Lake Portchartrain, La. + Vicinity Hurricane Protection Project - High Level Plan 17th St. Canal

SEEPAGE ANALYSIS REVIEW PUMP STA. No. 6, 17TH ST. CANAL, LAKE FORT, LA & VIC HURRICANE PROT. PROJ., HLP, ORLEANS PARISH, LA.

Recommended Sheetpile Cutoff
Beneath New Sliding Gate at
Pump Station No. 6
Jefferson Parish, Louisiana

Enclosure 1

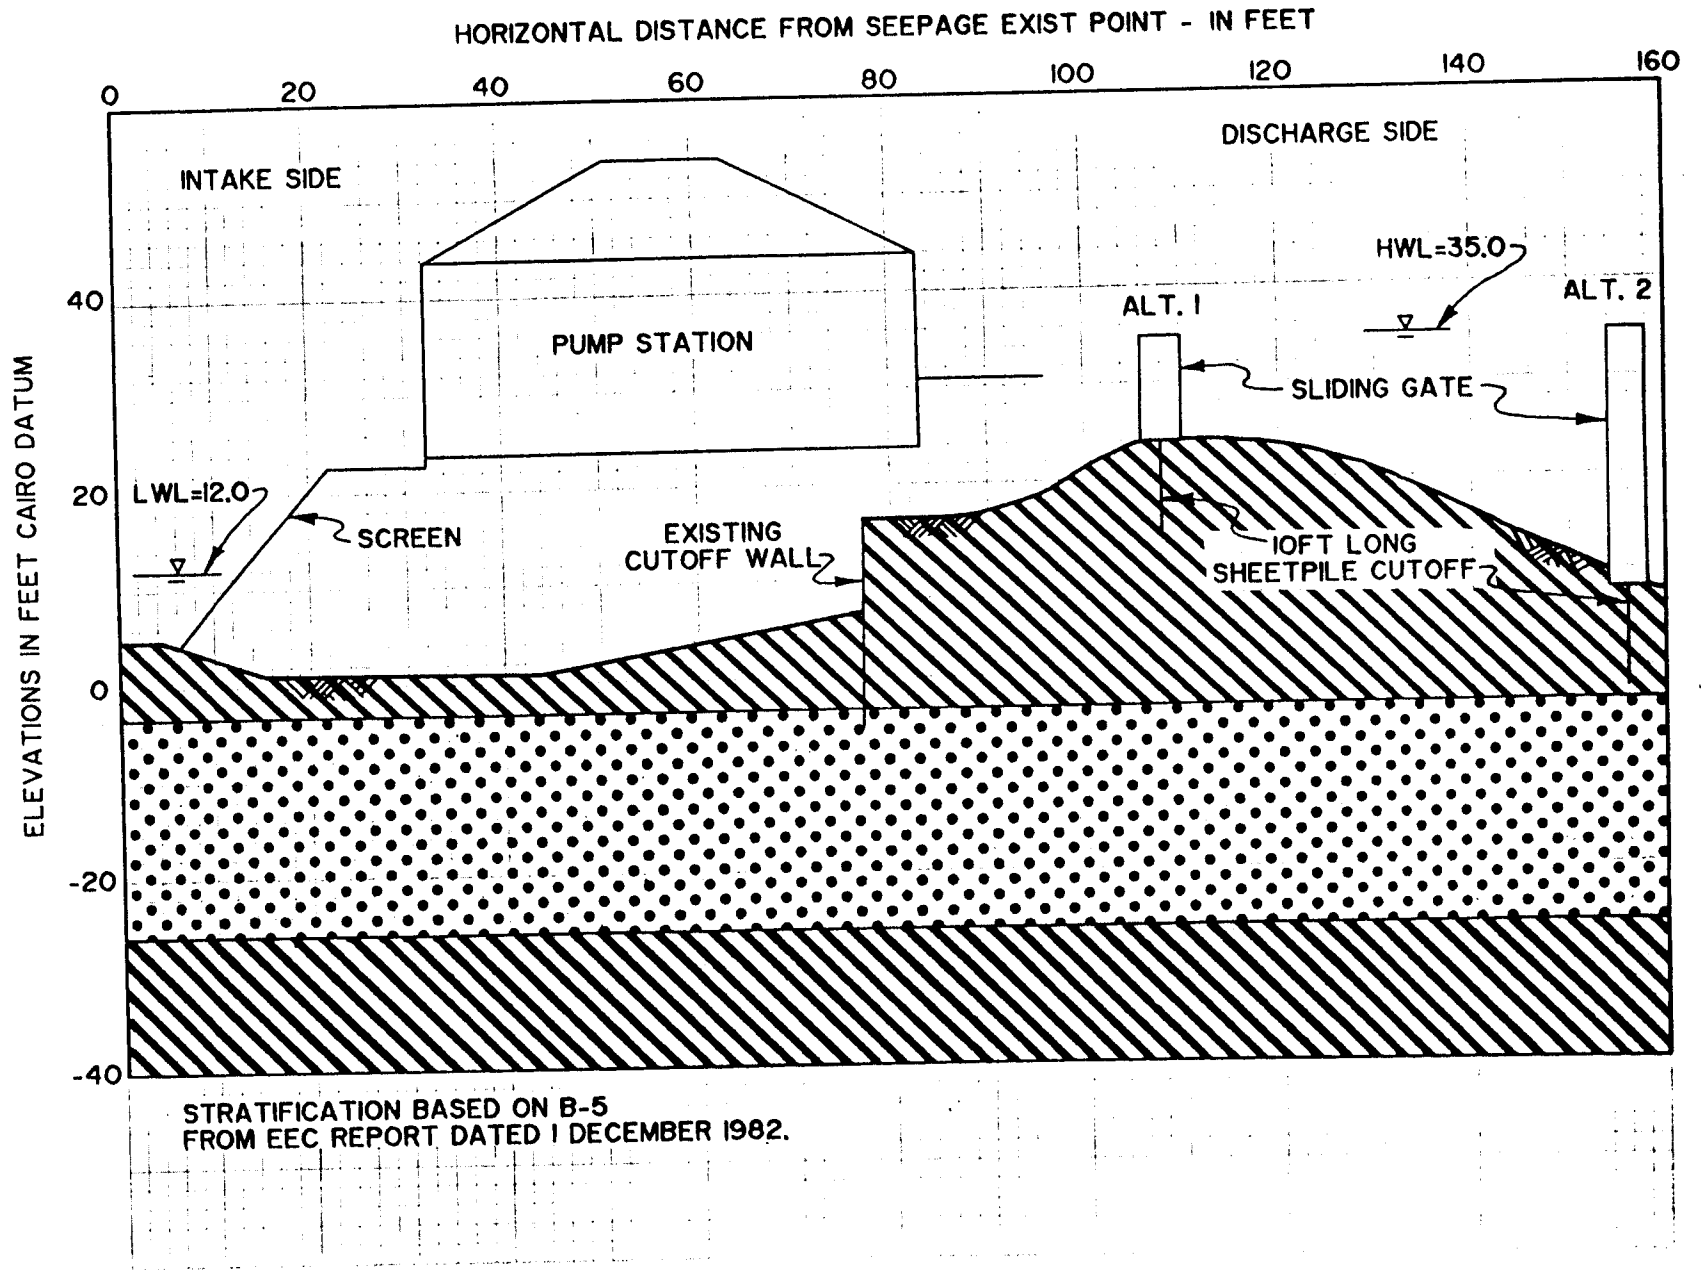
a.) The sheetpile penetration may be adequate for seepage under the pumping station but it is not adequate for a seepage path exiting at the protected side base of the floodwall for alternative 1 or 2. The final width of the floodwall base slab will affect the length of the seepage path. A more punctilious seepage analysis should be presented when the final plans are submitted.

b.) Blowout of the clay layer at the intake basin screen may occur at the normal hydrostatic elevation in the sand (from previous stability analyses by Eustis Engr.), for the section shown in enclosure 1. Instability at the screen does not affect hurricane protection but may require investigation by your geotechnical consultant.
